Project
Littleborough Family Hub Conversion
Calderbrook Road
Littleborough OL15 9JN

Title
PROPOSED ELEVATIONS

Dwg No.
A1/ 2005021/BS/28 C

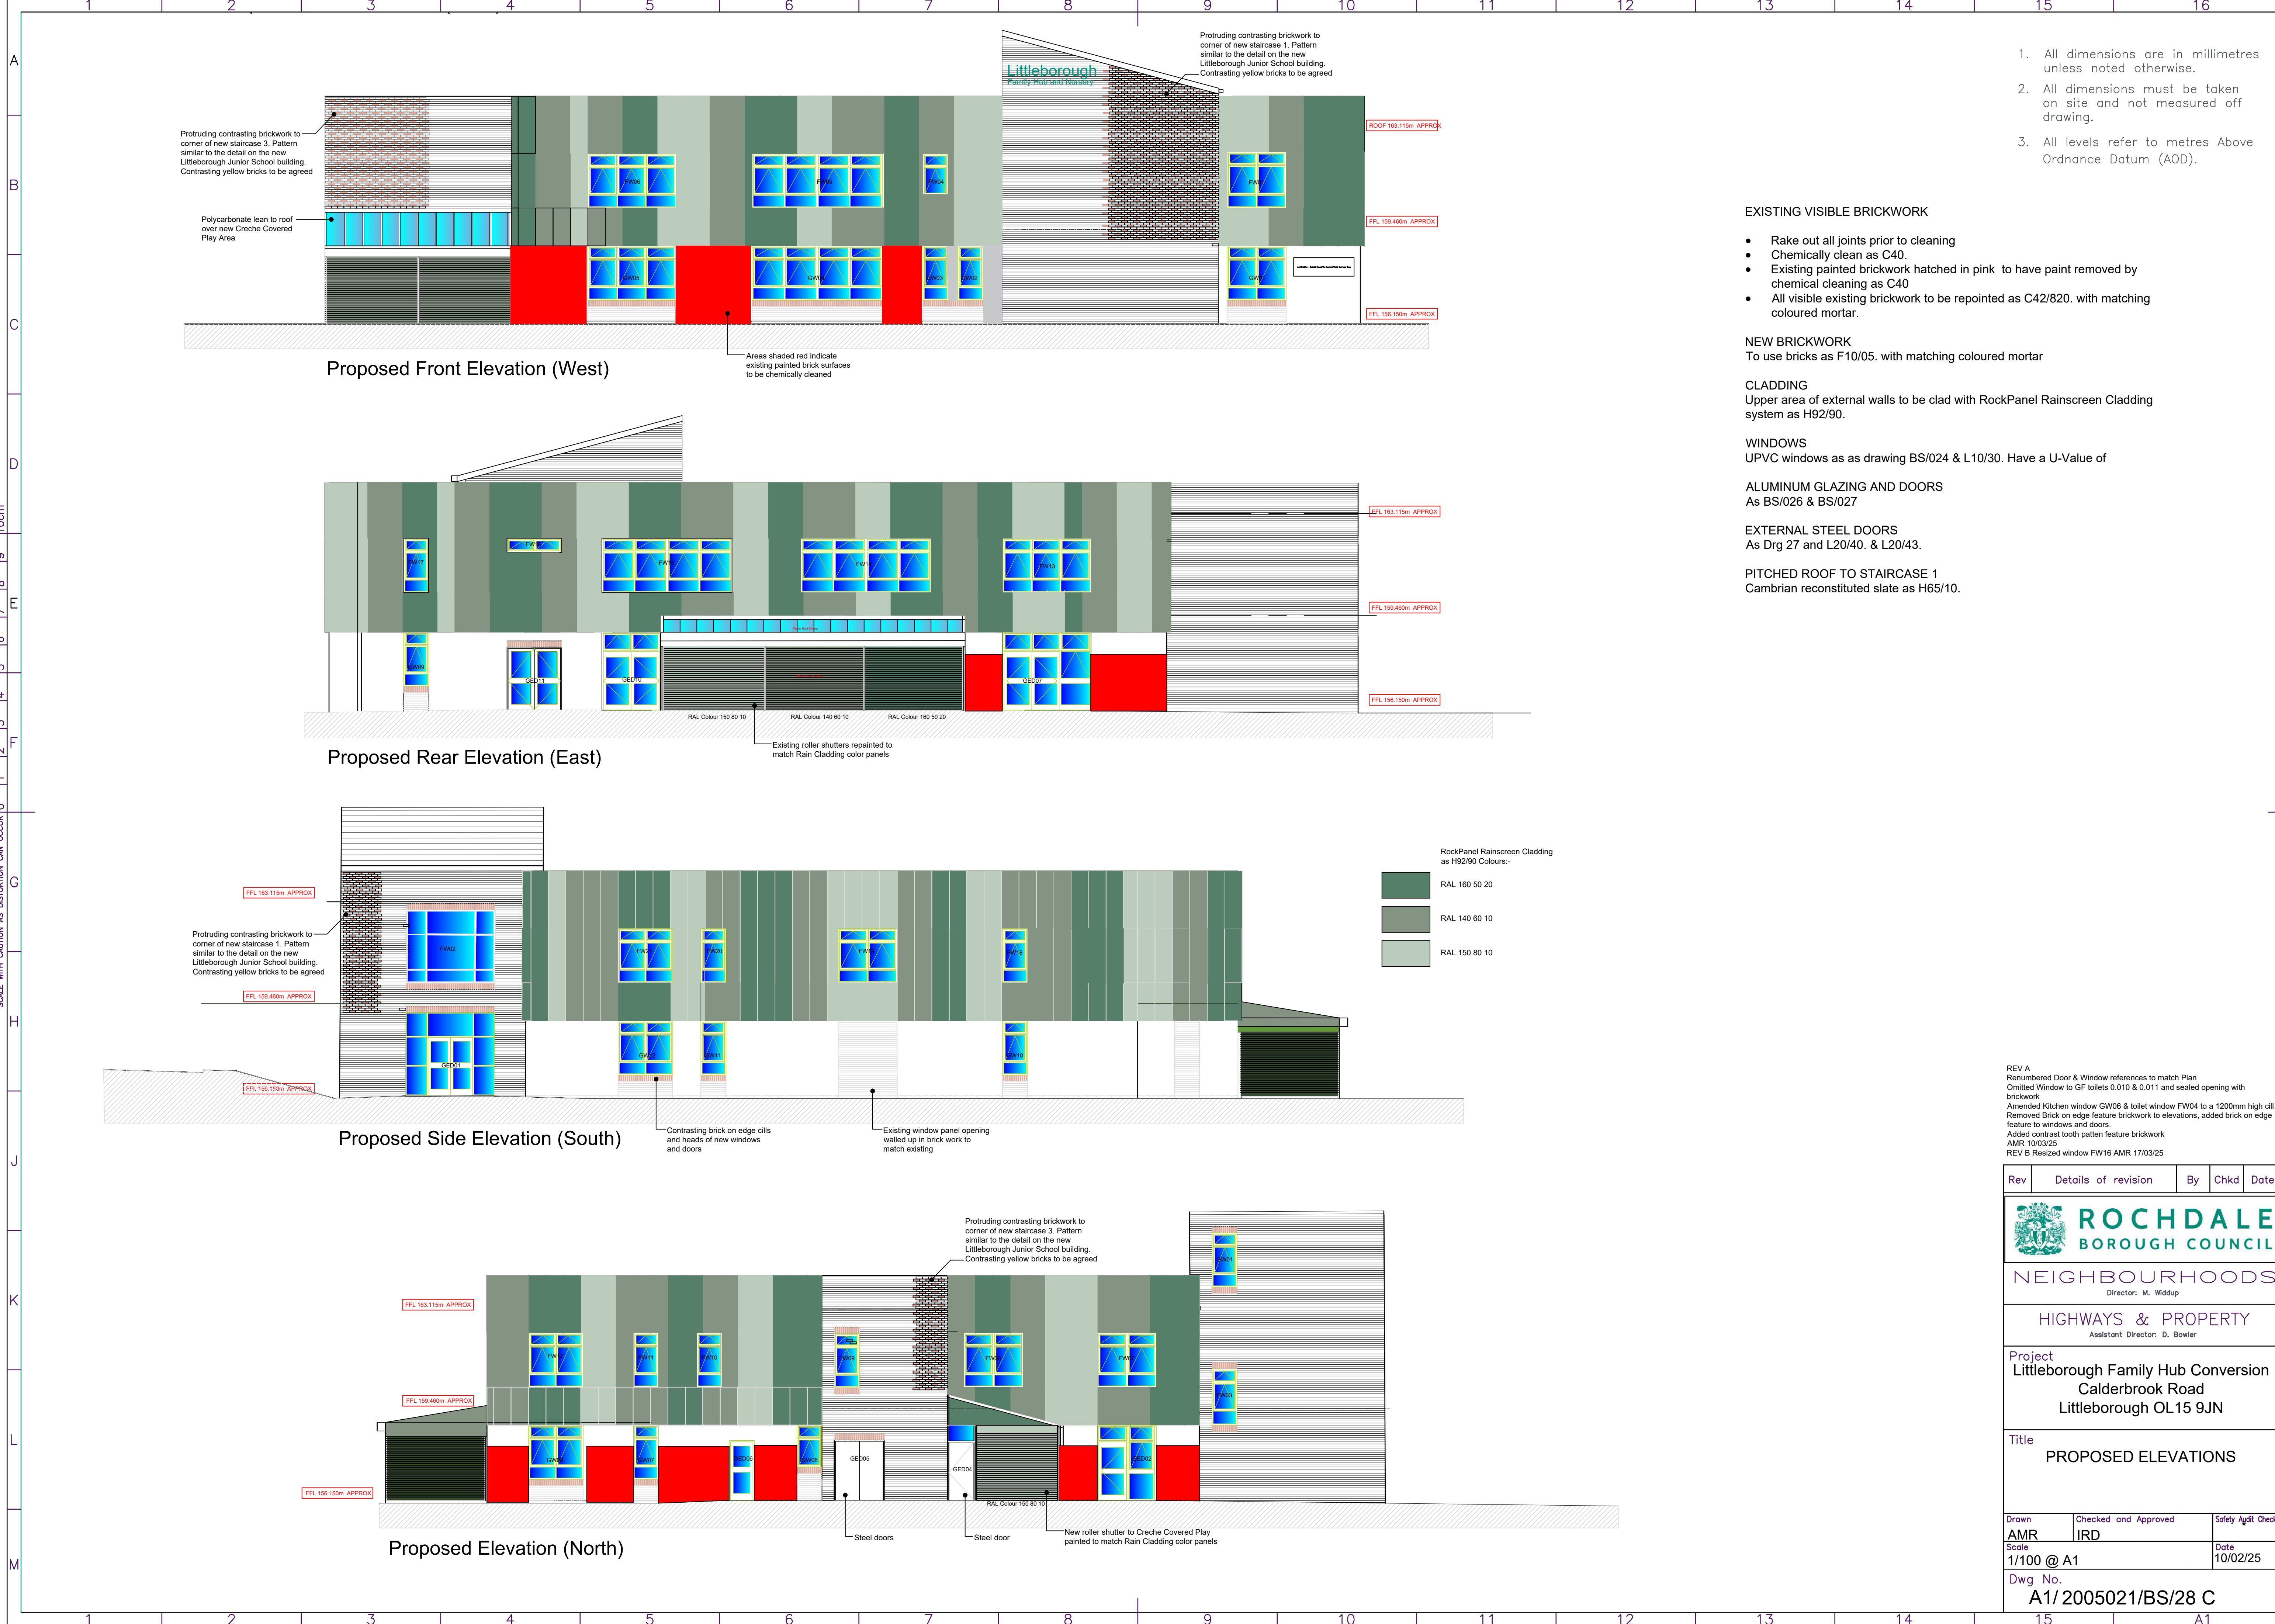
REV A
Renumbered Door & Window references to match Plan
Omitted Window to GF toilets 0.010 & 0.011 and sealed opening with brickwork
Amended Kitchen window GW06 & toilet window FW04 to a 1200mm high cill.
Removed Brick on edge feature brickwork to elevations, added brick on edge feature to windows and doors.
Added contrast tooth pattern feature brickwork
AMR 10/03/25
REV B Resized window FW16 AMR 17/03/25
